AGENDA

Resiliency Sub Workgroup

April 27th, 2022

Figure 7. Locations where design for tornado loads is not required for a Risk Category III building or other structure having an effective plan area $A_e = 100,000 \text{ ft}^2$, located in Exposure B (top) and Exposure C (bottom).

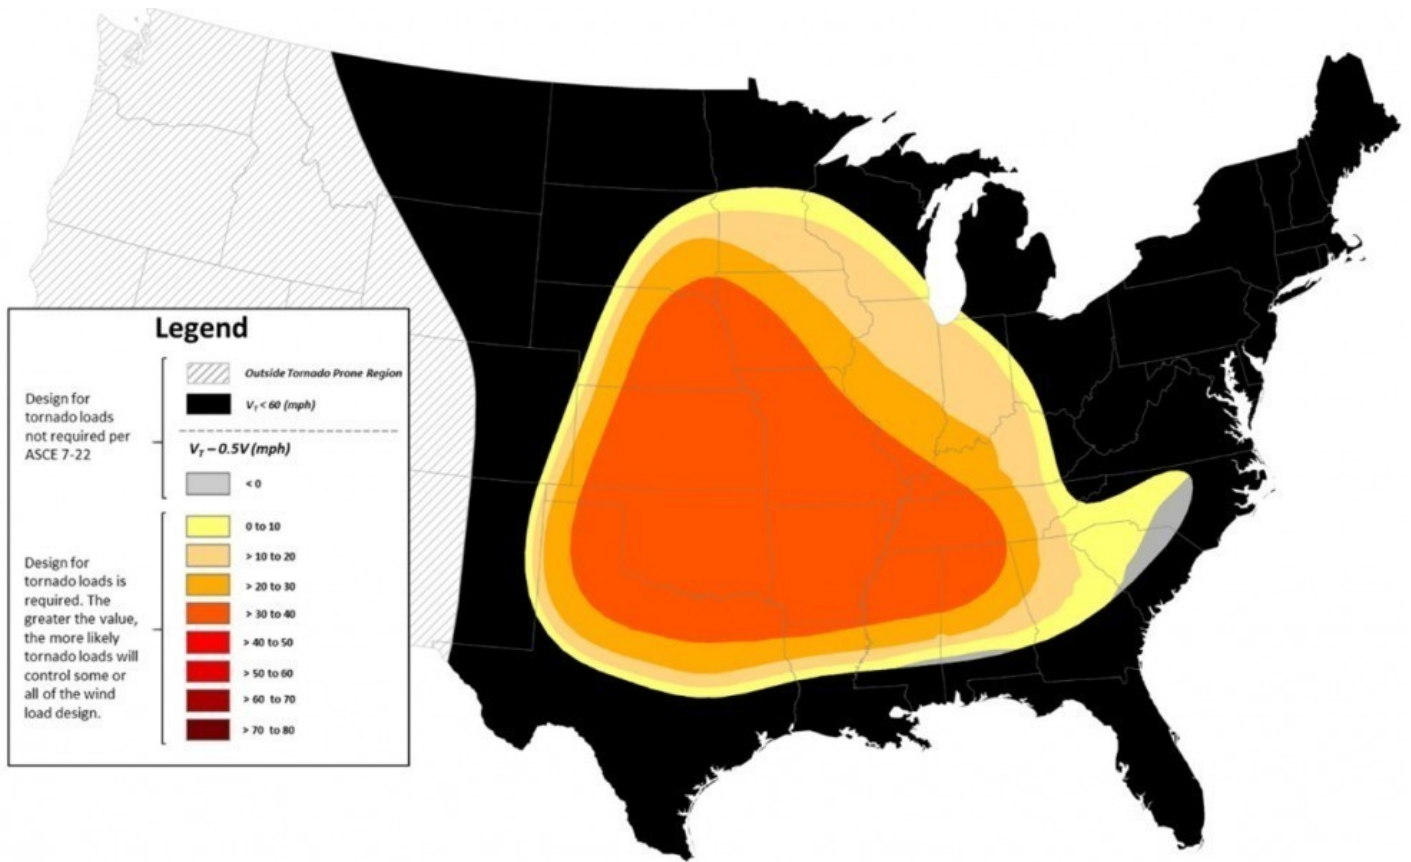
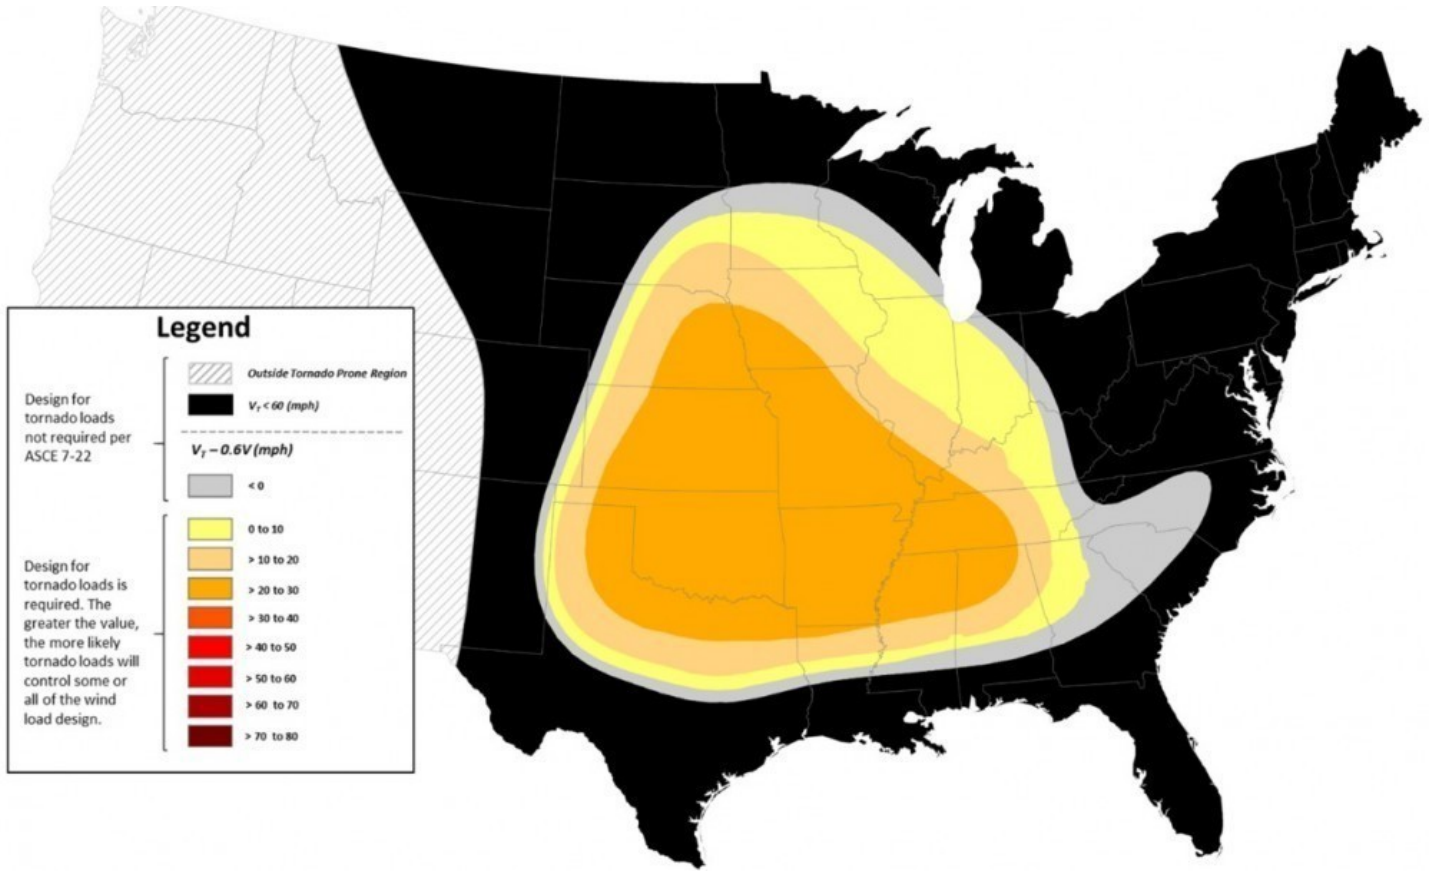
For a medium-sized Risk Category III building, the tornado speeds are less than 60 mph across much of the tornado prone region (Figure 7). Tornado loads are required only in the areas shaded with the warm colors, which spans roughly between north Texas, central Minnesota, and the central Carolinas. In contrast, tornado loads are required across most of the tornado-prone region for very large Risk Category IV facilities, except New England and small areas of south Florida and south Louisiana for Exposure C (Figure 8). In both figures, the darker reds indicate areas that tornado loads are more likely to exceed wind loads. In general, tornado loads are more likely to control at least some element(s) of the wind load design for buildings and other structures that have one or more of the following characteristics:

Figure 8. Locations where design for tornado loads is not required for a Risk Category IV building or other structure having an effective plan area $A_e = 1,000,000 \text{ ft}^2$, located in Exposure B (top) and Exposure C (bottom).

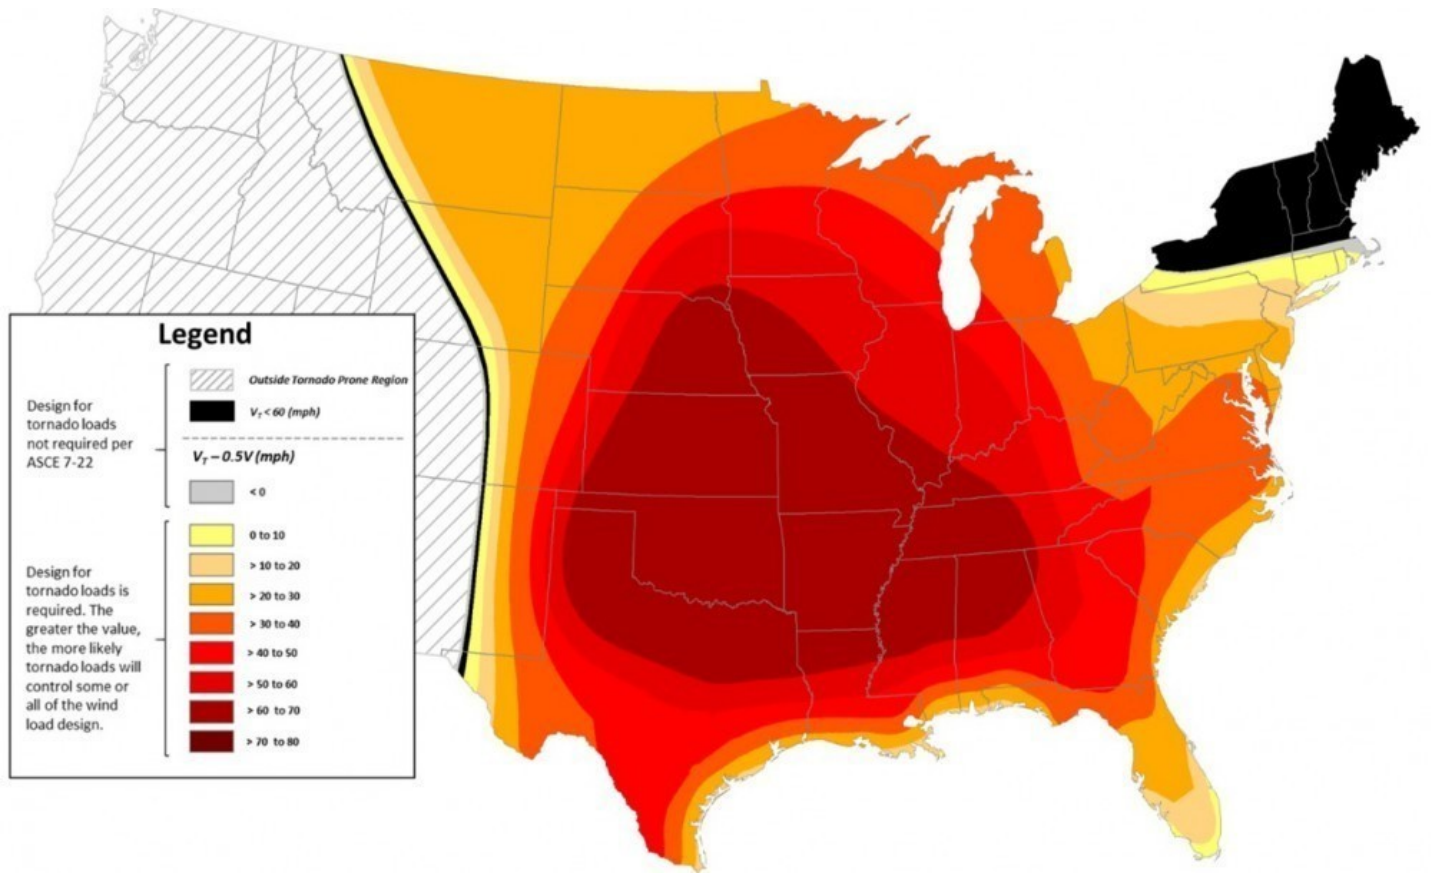
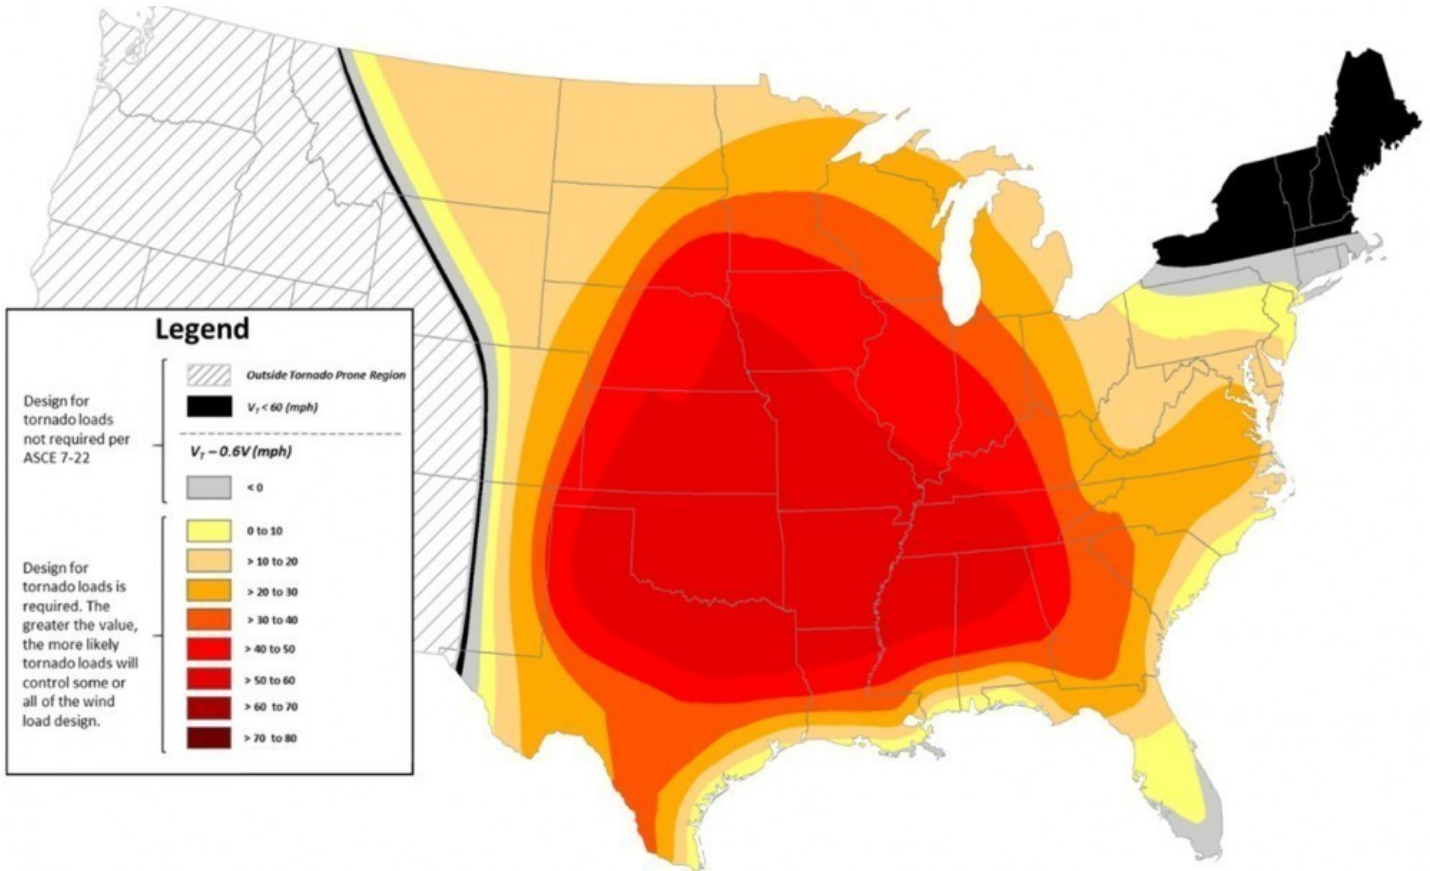
Maps were created to show where design for tornado loads is not required, based on the tornado speed criteria in the previous paragraph. Examples for a medium size Risk Category III facility and a very large Risk Category IV facility are shown in Figures 7 and 8, for both Exposures B and C. At locations where the tornado speed is greater than the specified percentage of the basic wind speed, design for tornado loads is required but may still not control. This is because the net pressure loading patterns on a building are different for tornadoic versus non-tornadoic winds, due to the differences in wind and wind-structure interaction characteristics which are reflected by factors 4 through 8 above.
